ADDENDUM NO. Three (3)
PROJECT NO: 112741
TITLE OF PROJECT: Headquarters HQ Replacement Phase 1
FACILITY LOCATION: Tyler State Park, Smith County, Texas

ADDENDUM NO. 3

Tyler State Park
Headquarters
TPWD Project Number 112741
FPC Project Number 92705
October 8, 2020

1 T203 TECHNOLOGY ENLARGED FLOOR PLAN AREA B
3/16" = 1'-0"

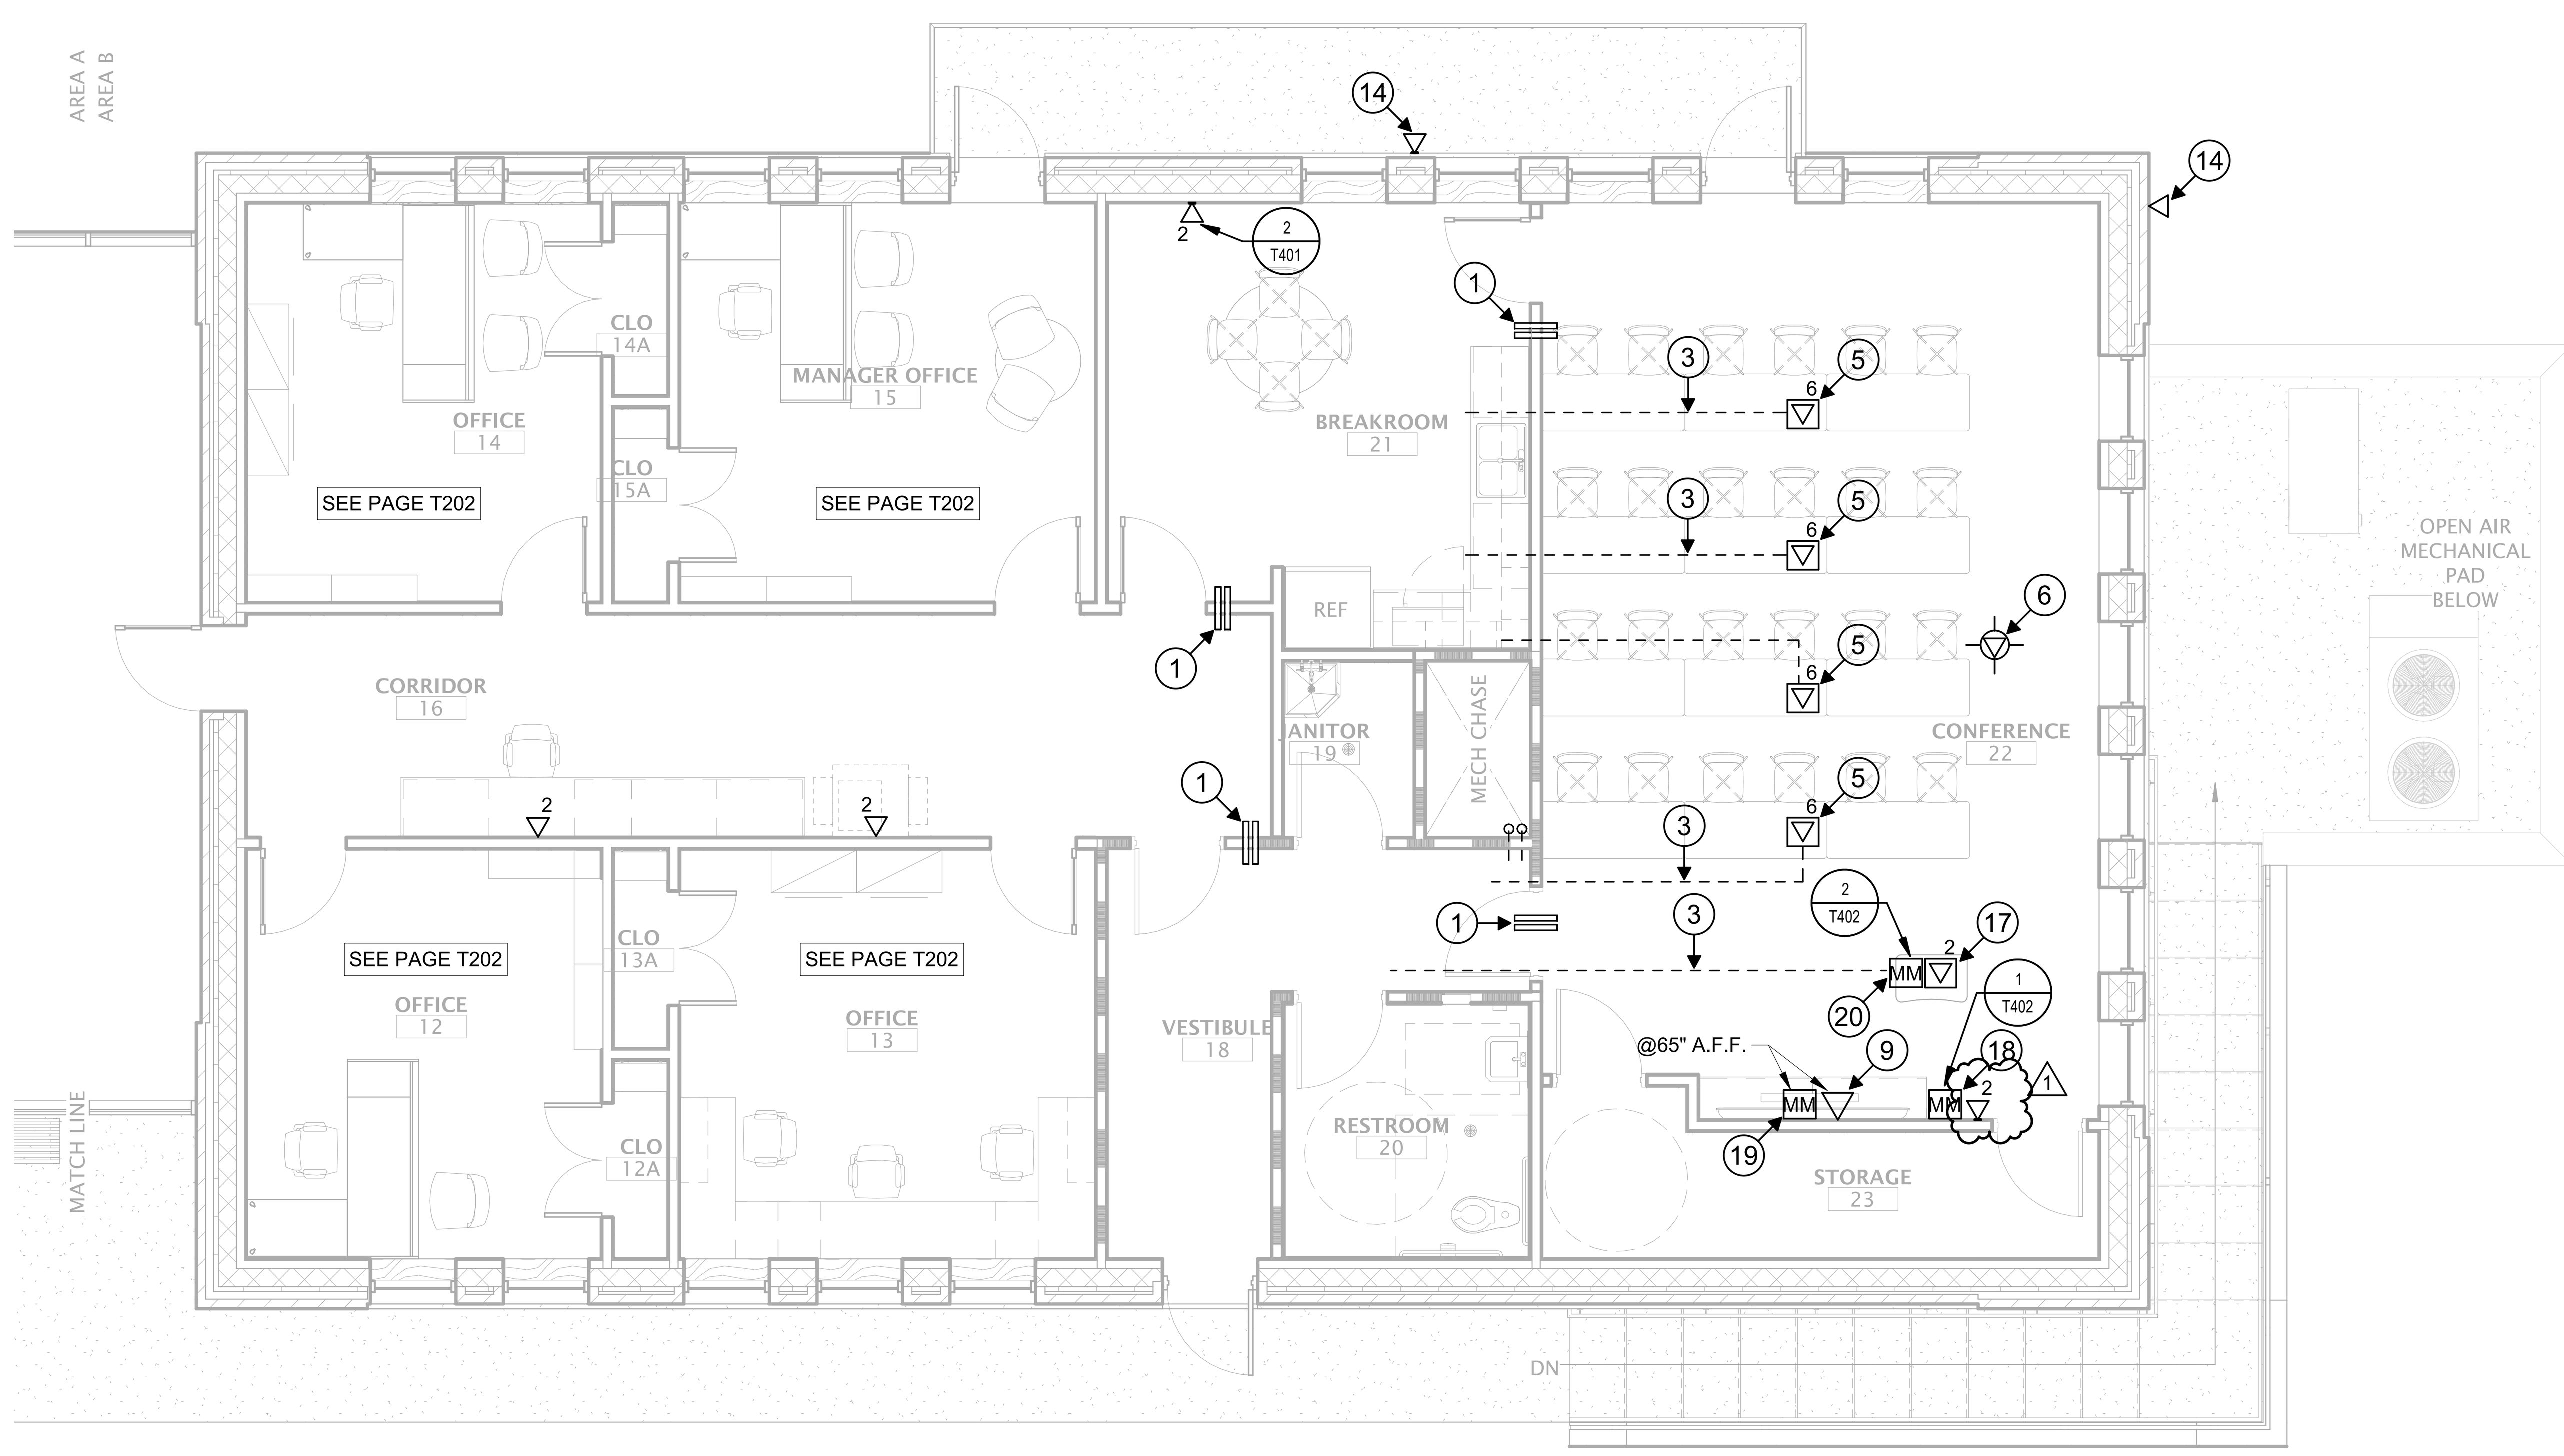
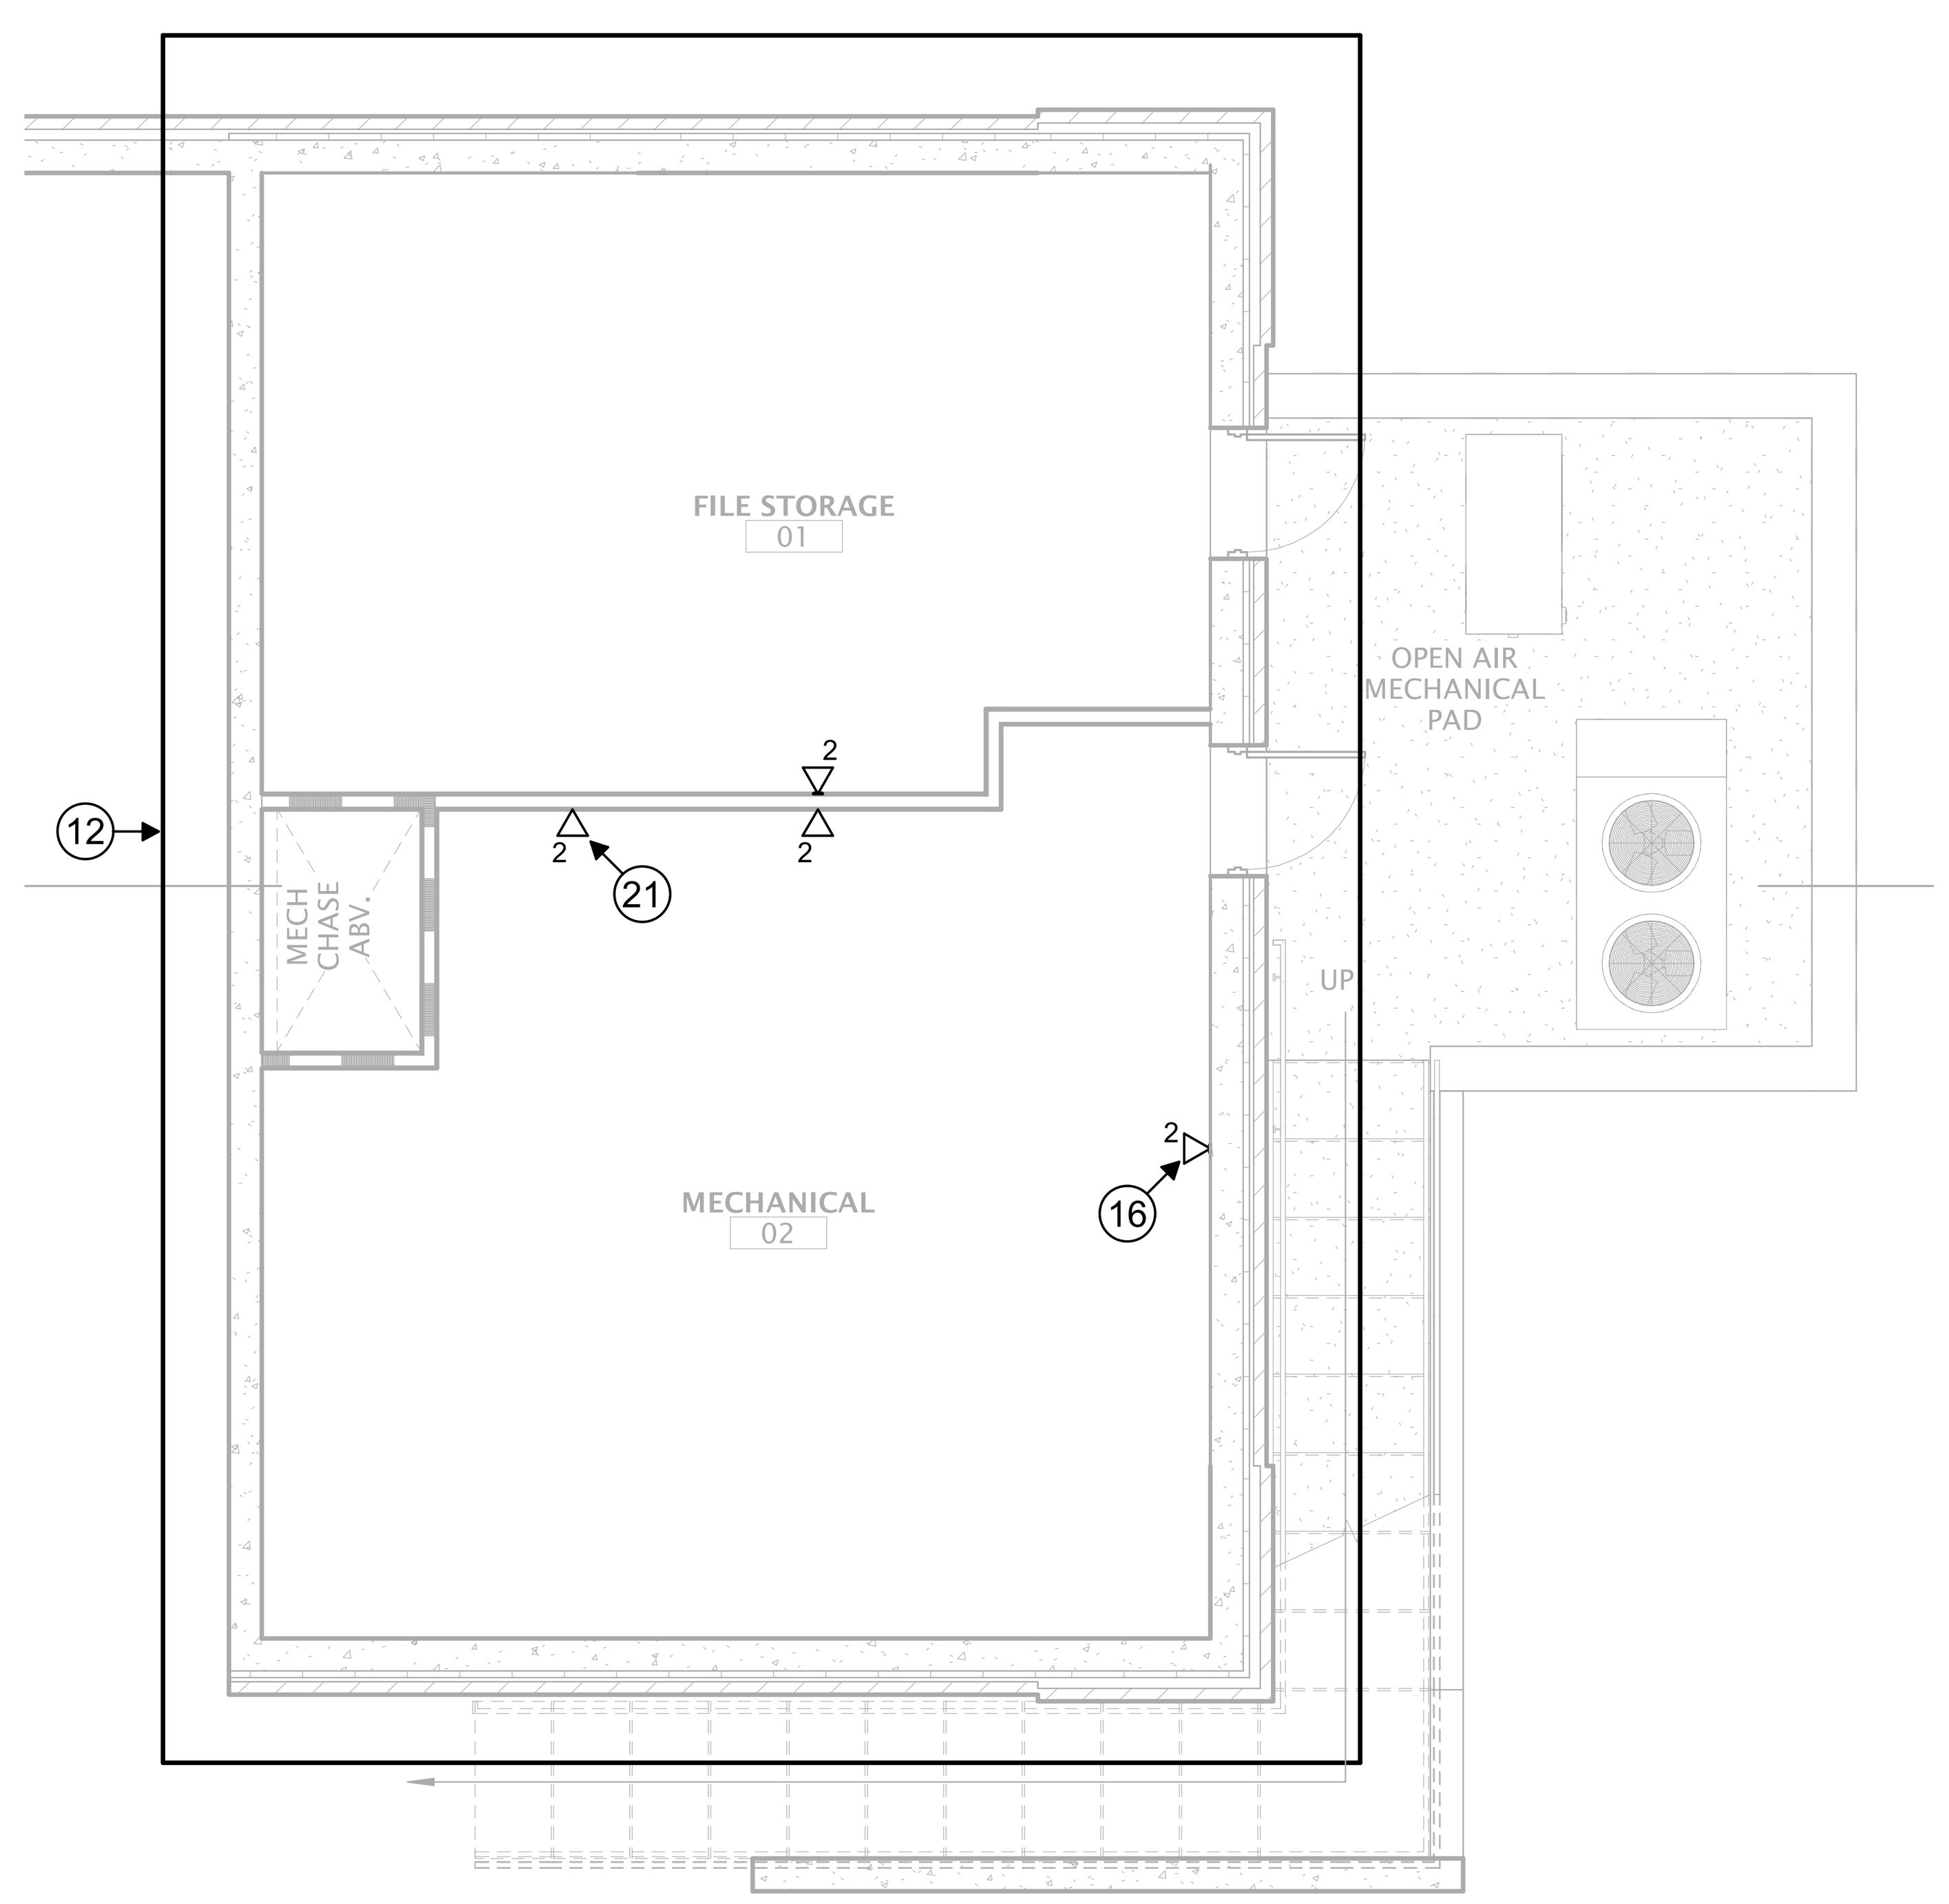
Item #3
-Page T203- Add data outlet next to the to the Multimedia location.

1 / T301 IT ROOM LAYOUT - MTC
1/2" = 1'-0"

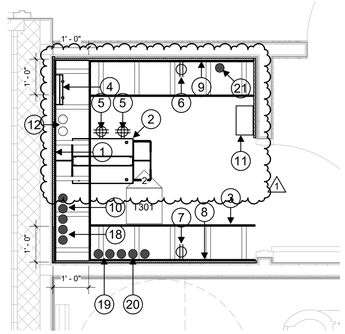
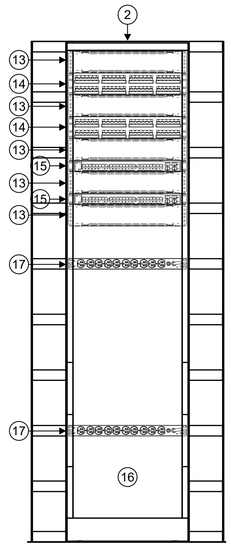
Item #4:
-Page T301 - Add (1) quad 20amp outlet above the equipment rack.

-Page T301 – Add (1) grounding rod (by div 26) at the service provider wall field to support the service provider grounding requirements. The ground rod shall be grounded to the busbar in the room by Division 26.

3 ELEVATION
SCALE: 1-1/2"=1'-0"

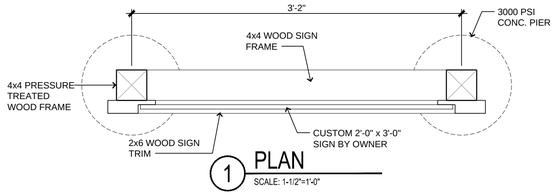
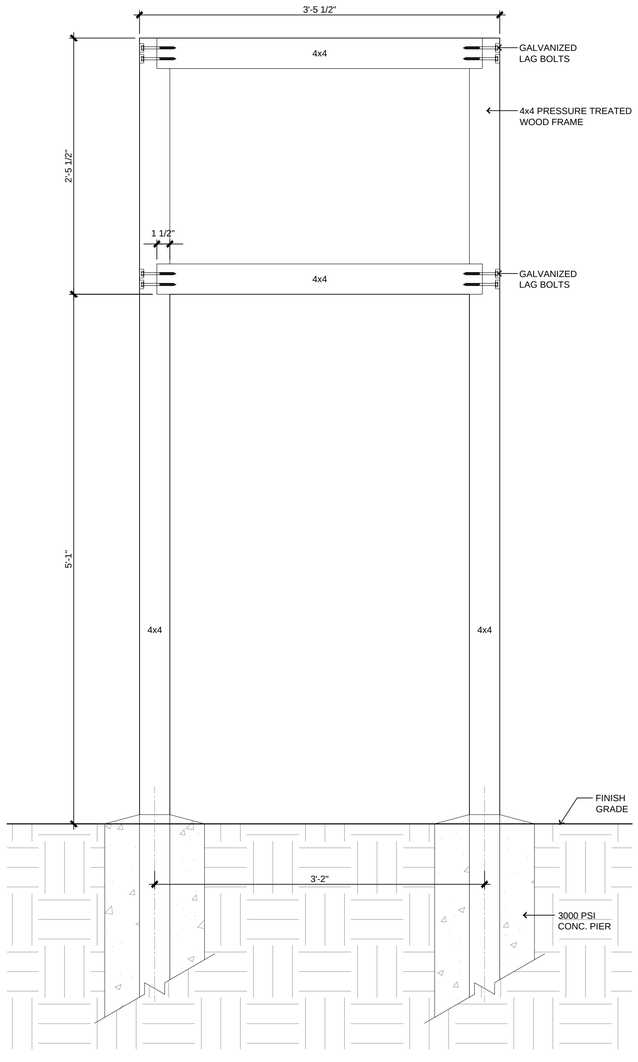
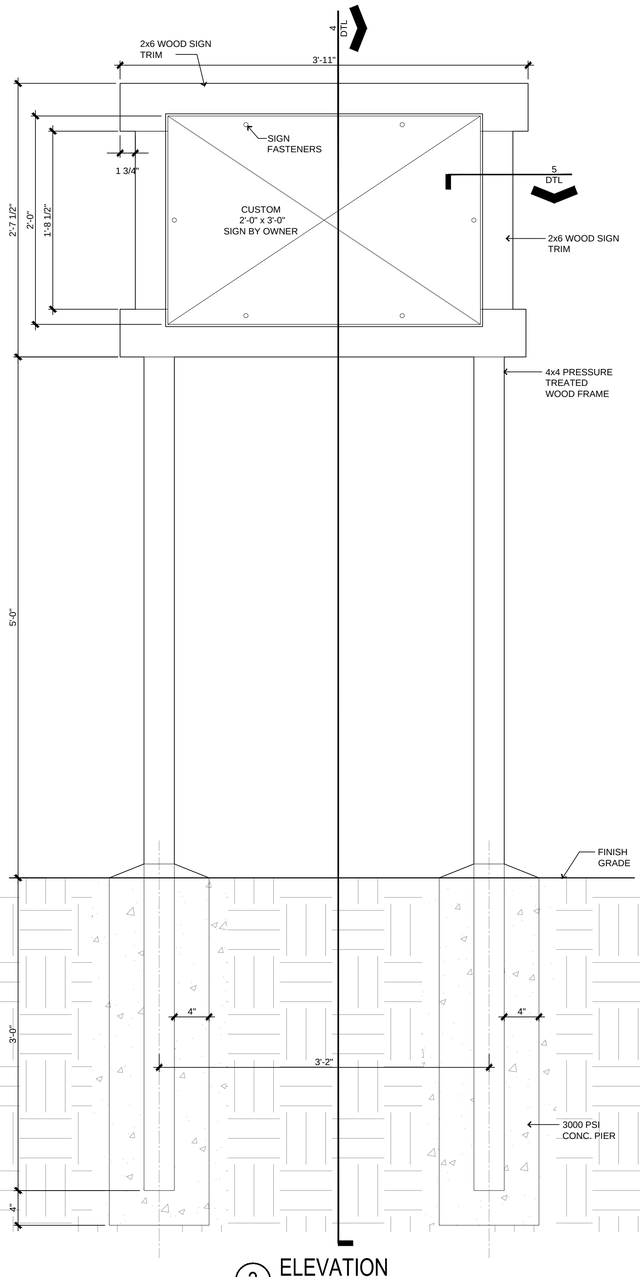
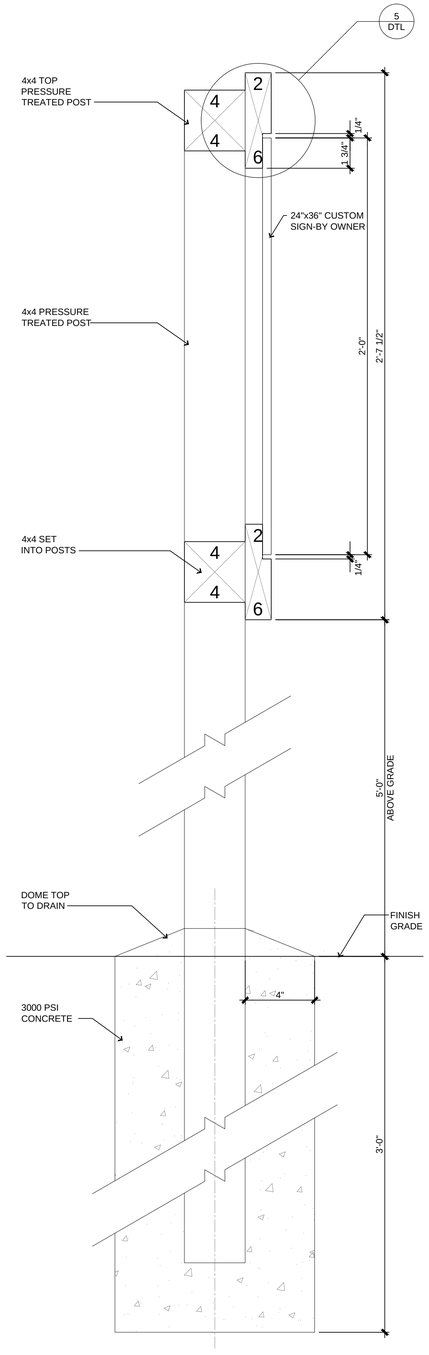
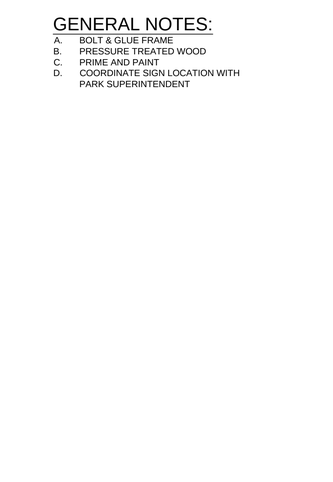
ITEM 4.01 SHEET SIGN

Add erection of a sign to be displayed during construction. Owner to provide graphics for sign at a later date. Owner to demolish sign at close of TxDOT phase of construction. Coordinate sign location with Owner.
